# Request for Proposal

Date: 8/9/2023  
Project Name: UA 310 ARKV Renovation  
Project No.: 21085  
Owner: University of Arkansas - Fayetteville

**RFP NO: 02**

PROPOSAL REQUEST NUMBER: TWO (2)

**M2.01**

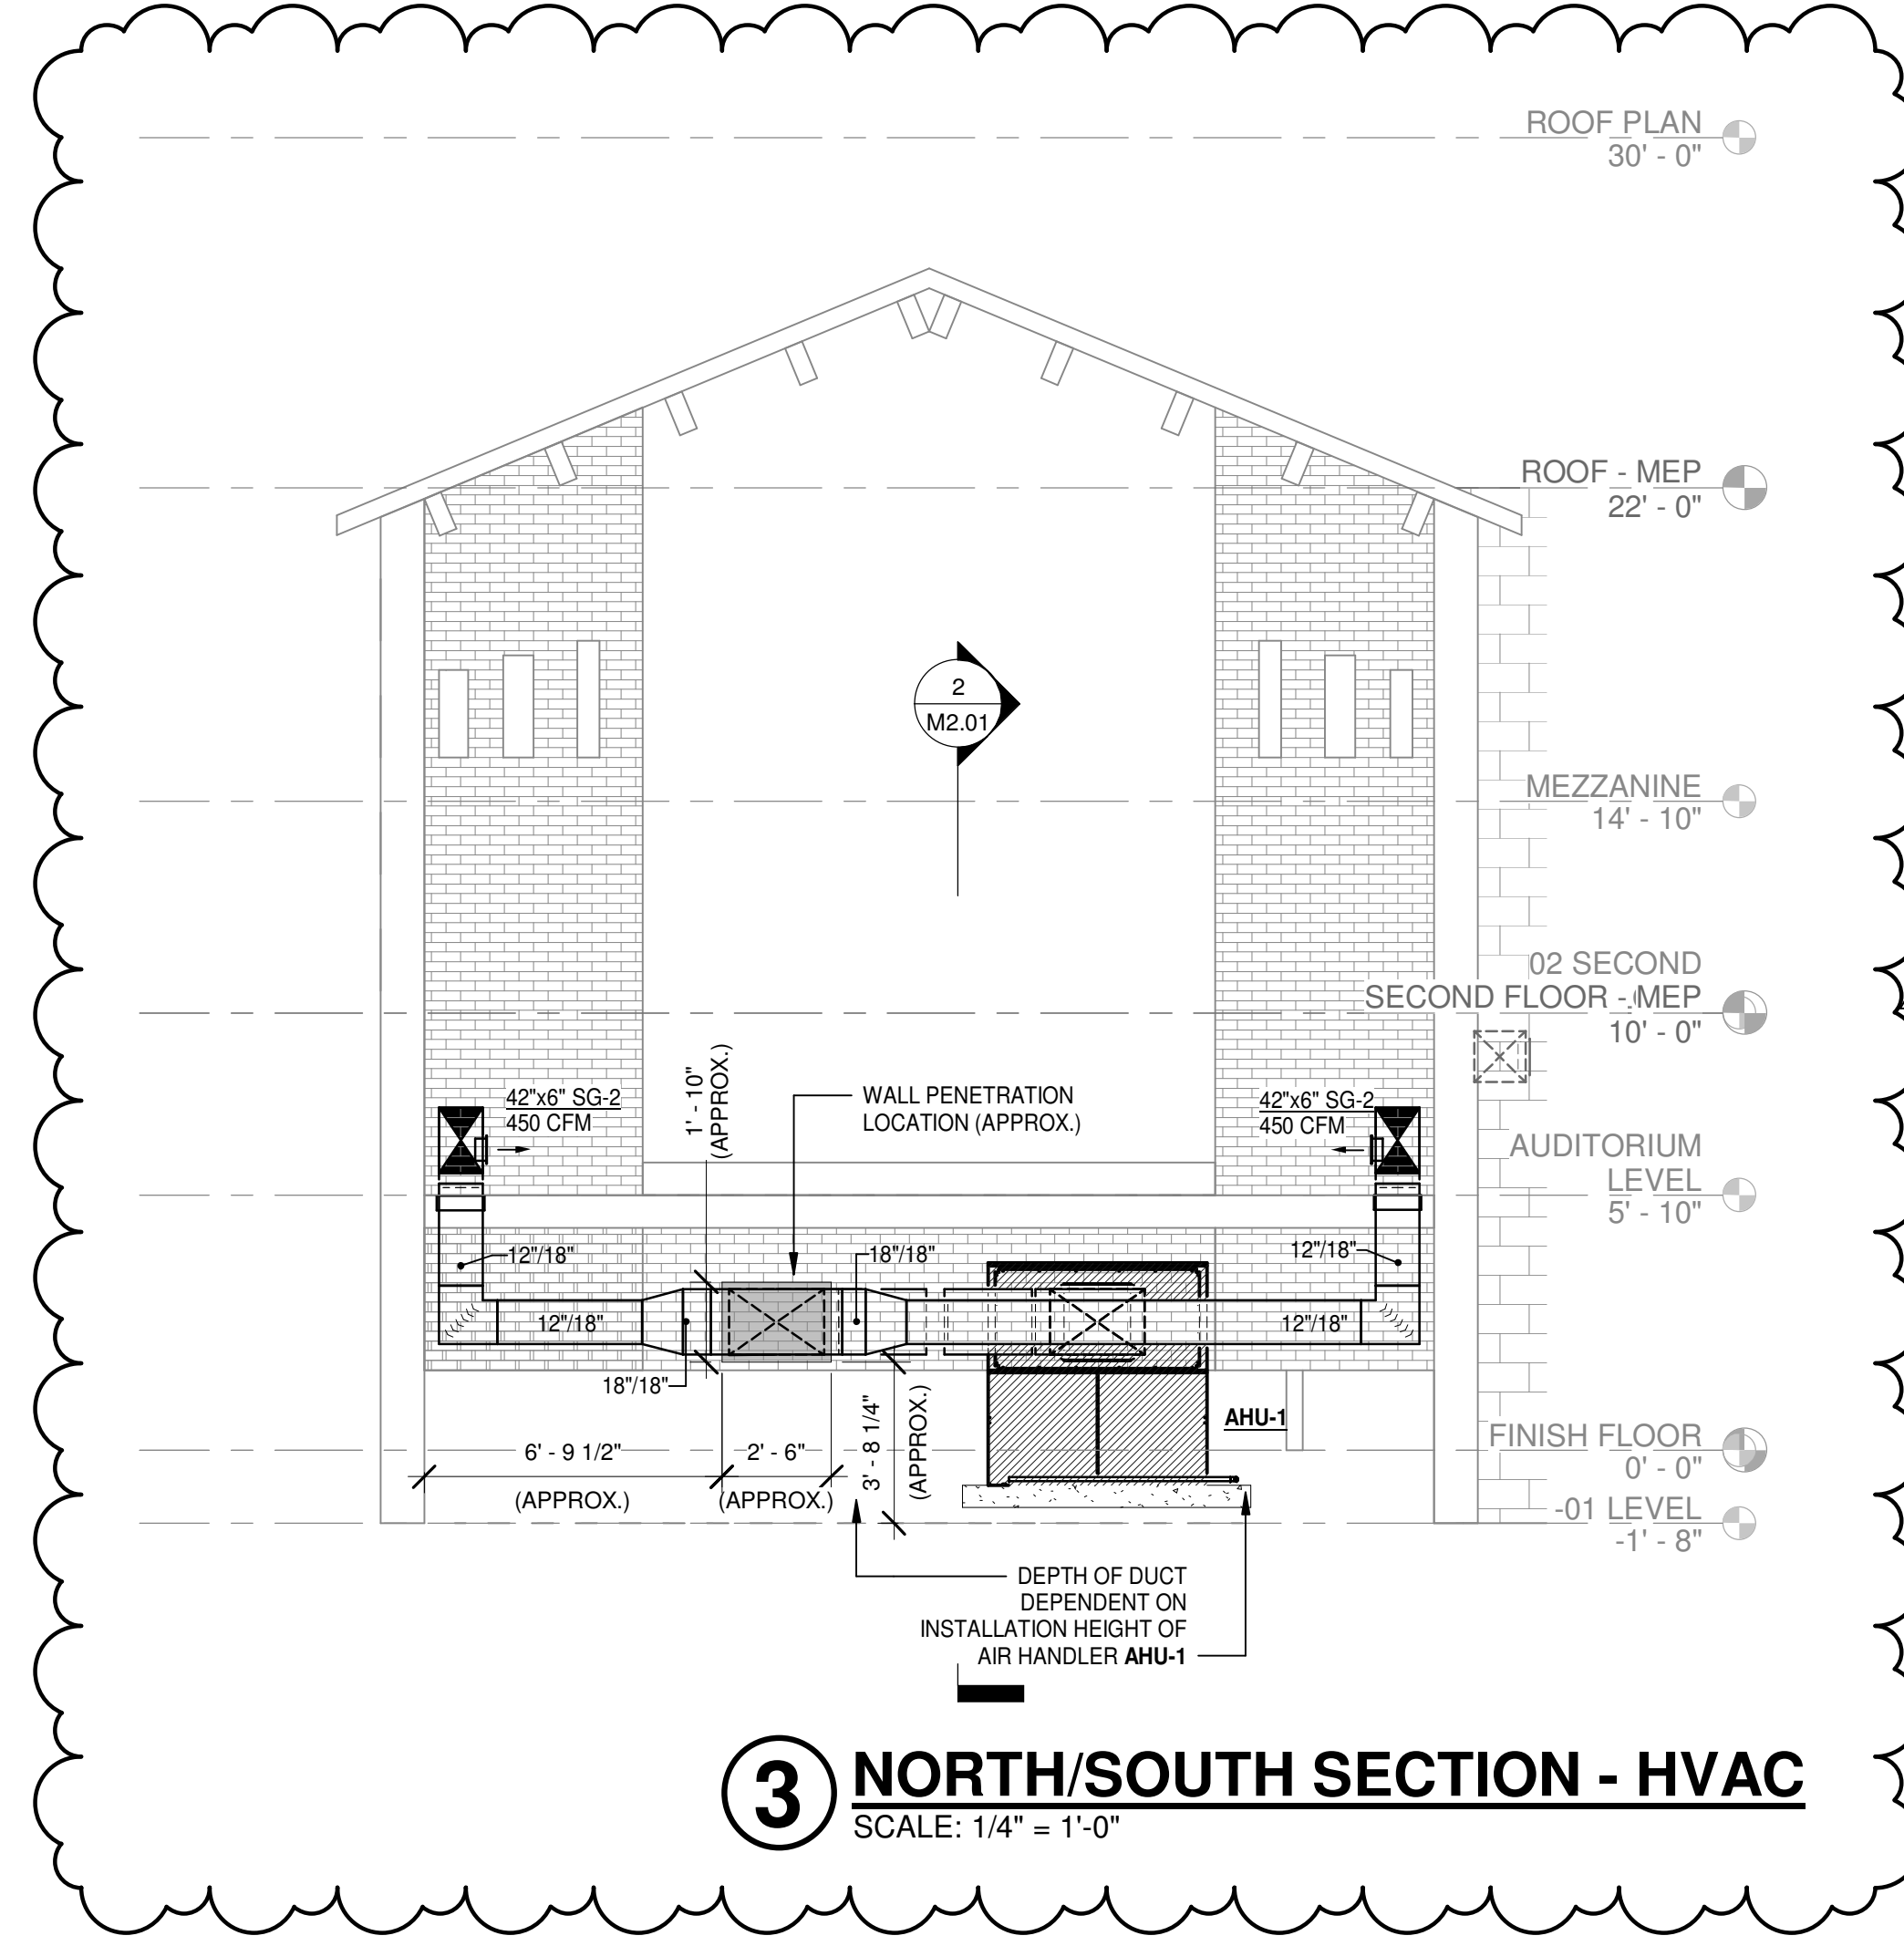
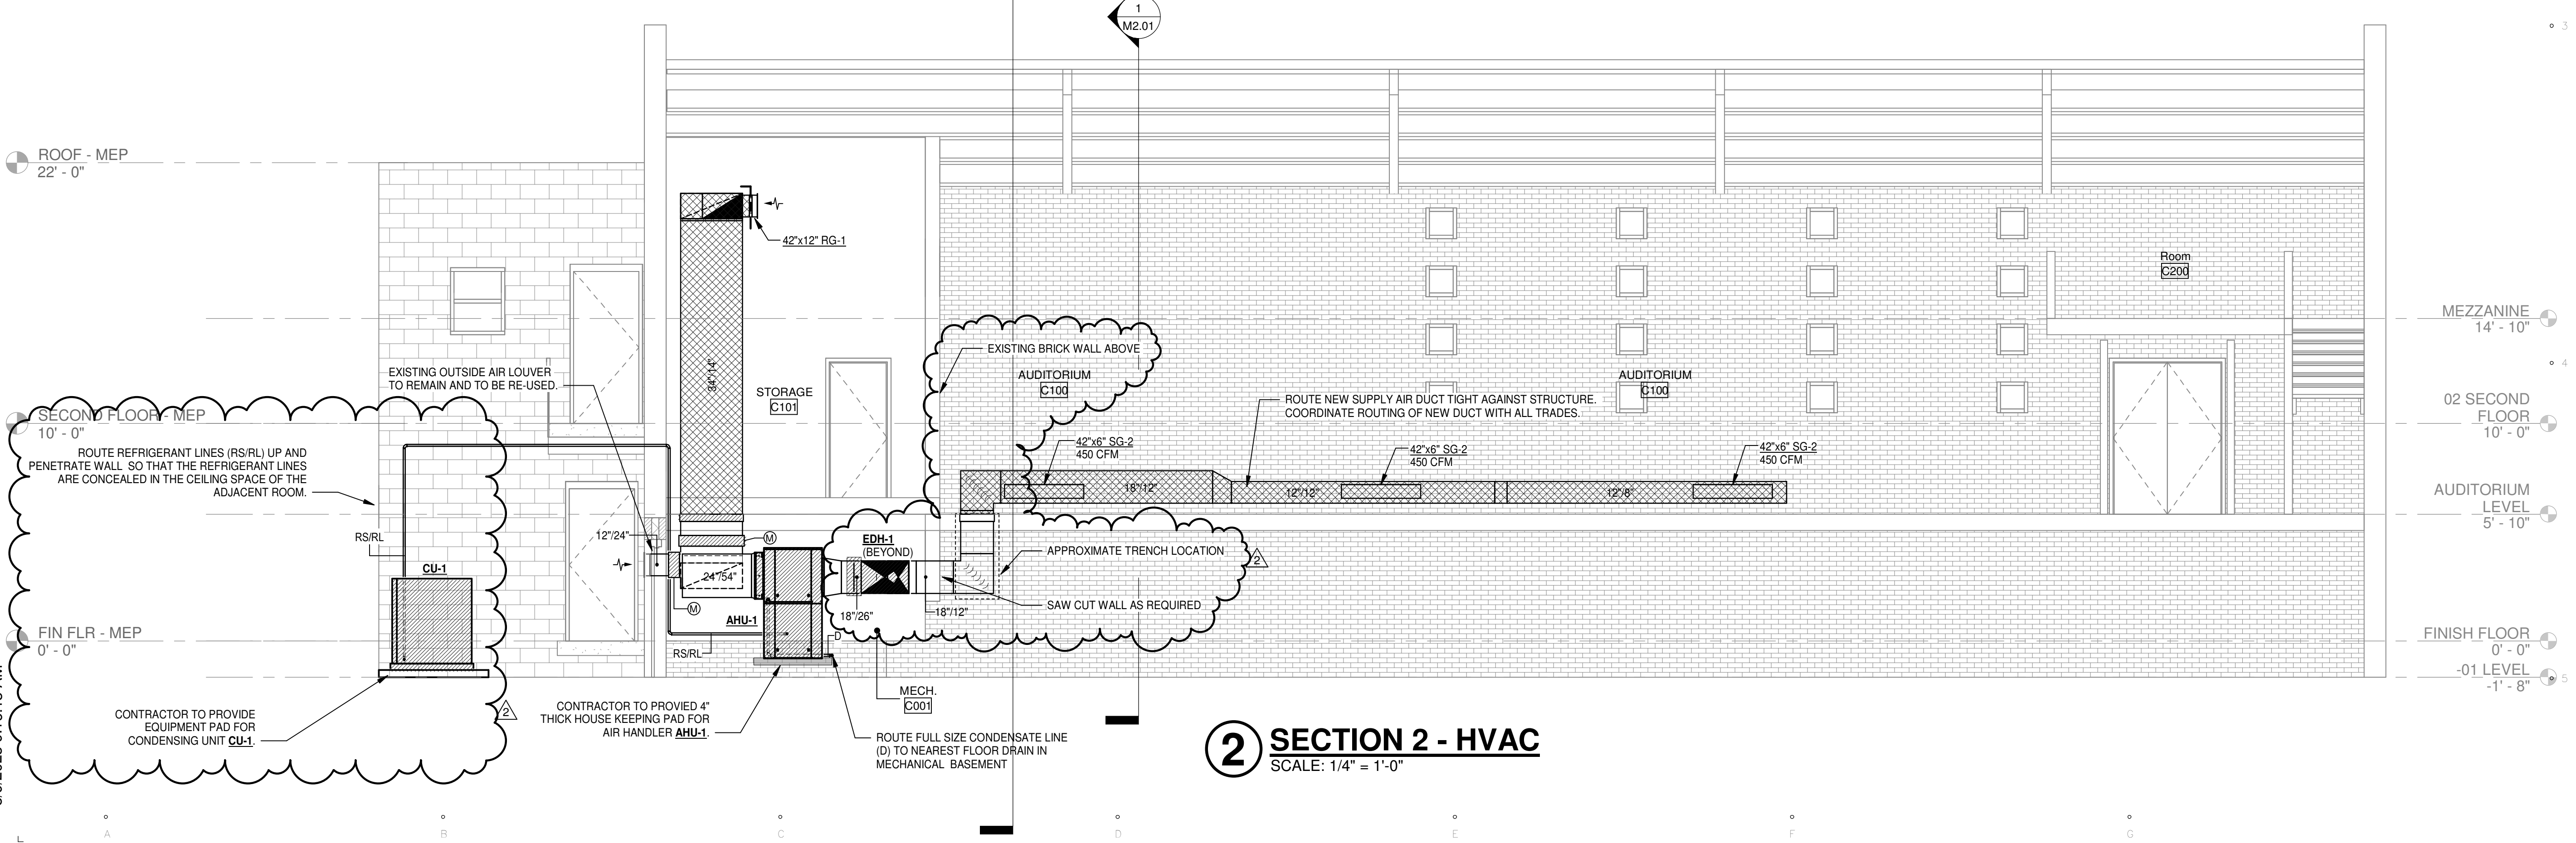
- A1.** REFER TO SHEET M1.01 AND M2.01 FOR DUCTWORK ROUTING REVISIONS. ADDITIONALLY, EDH-1 HAS BE REVISED AND RELOCATED, EDH-2 HAS BEEN DELETED, AND CU-1 HAS BEEN RELOCATED.
- A2.** REFER TO SHEET M4.01 REVISIONS TO THE DUCT HEATER SCHEDULE.
- A3.** REFER TO SHEET M5.01 REVISIONS TO THE DUCT HEATER CONTROLS DIAGRAM AND SEQUENCE OF OPERATIONS.
- A4.** REFER TO SHEET E1.03 FOR REVISIONS TO THE DUCT HEATER EDH-1 AND THE DELETION OF EDH-2. CU-1 WAS ALSO RELOCATED.
- A5.** REFER TO SHEET E2.01 FOR REVISIONS TO PANEL "A". A NEW 125A/3P BREAKER SHALL BE PROVIDED FOR EDH-1. THE ORIGINAL BREAKERS FOR EDH-1 AND EDH-2 SHALL BE LABELED AS SPARE.
